Type IV - Annexation with Zone Change –Park Place
Planning Commission April 9, 2018

Subject: PA-16-57: Park Place 91 Acre Annexation & Zone Change

Date: April 6, 2018
To: Pete Walter, City of Oregon City
From: Christian Snuffin, P.E., PTOE, Clackamas County
Rick Nys, P.E., Clackamas County
Subject: AN 17-0004 / ZC 17-0005: Park Place Annexation and Rezoning of 92 acres

Figure 1 - Functional Classification Map from Park Place Concept Plan

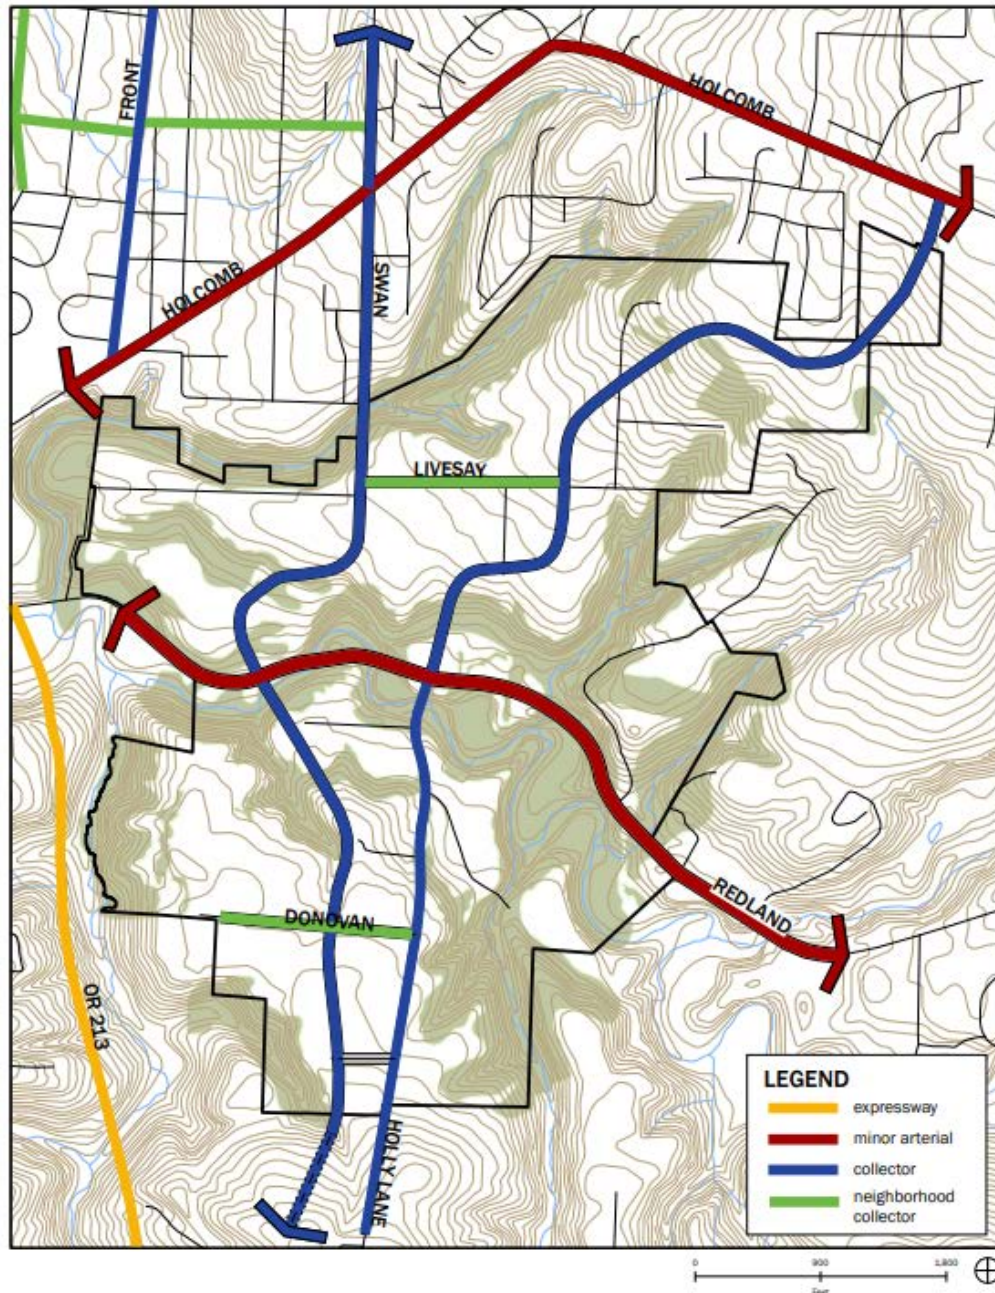
The intent of development in the annexation area is not to rely on Livesay Road west of the project site. The roadway is generally narrow and unimproved. For this reason, the original TIS did not assign trips to the roadway or rely on it for access. The Park Place Concept Plan considers a functional upgrade to Livesay Road to a Neighborhood Collector classification between the planned Swan Avenue and Holly Lane extensions. This is shown in Figure 1 below, which is the Functional Classification Map from the Concept Plan. Consistent with the Concept Plan, development on the site is intended to rely on streets other than Livesay Road.

Traffic impacts to Livesay Road should be carefully monitored and controlled during the Master Plan process. This can be accomplished through the thoughtful timing and configuration of new street connections to development in the Park Place area, which can be done strategically to emphasize the use of new higher-classification facilities such as the Swan Avenue and Holly Lane extensions.

For these reasons, the evaluation of the intersection of Livesay Road and Redland Road is not necessary at this time. Rather, impacts to Livesay Road should be carefully examined and minimized as development occurs through the Master Plan process.
